356 / POL 7

CERTIFICATE OF JUMPING HILL CERTIFICAT DE **CONFORMITE SCHANZENPROFILBESTÄTIGUNG**

Zakopane

Krokiew 65

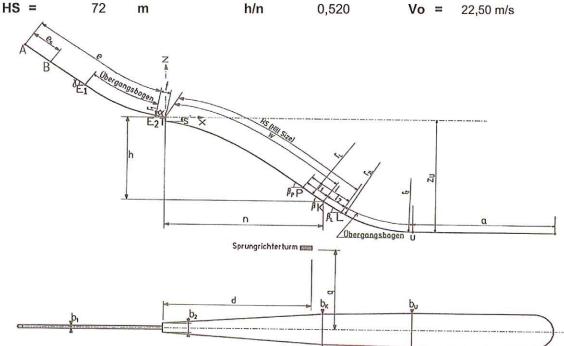
- 1.) inrun: the wooden topping between sidebars must be repaired
- 2.) inspection-report 02.11.2013 by Josef Slavik
- 3.) recommendation to redesign the outrun-profile and table (high flight-level)
